UNITED STATES PATENT AND TRADEMARK OFFICE

APPLICATION NO.	FILING DATE	FIRST NAMED INVENTOR	ATTORNEY DOCKET NO.	CONFIRMATION NO.
10/066,066	01/31/2002	Robert W. Aukerman	P 1028.11004	2497

Office Action Summary

DETAILED ACTION

U.S. Patent Jan. 13, 2003 Sheet 1 of 8 US 6,176,184 B

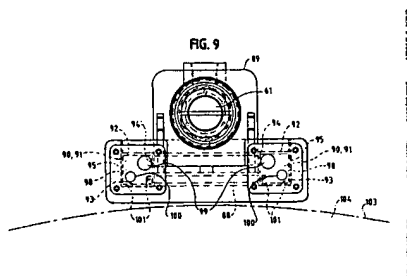
- {claim 1} An ink drying system (column 1, lines 5-9), coupled to a source of pressurized gas (figure 2, references 41, 57),

and comprising a plurality of plenums (figure 9, references 90),

each plenum including an associated plurality of orifices (figure 9, reference 101); a plurality of fluid flow valves for controlling fluid communication between the plenums and the source of pressurized gas (figure 2, reference 42); a controller (figure 2, reference 56; column 3, lines 29-52)
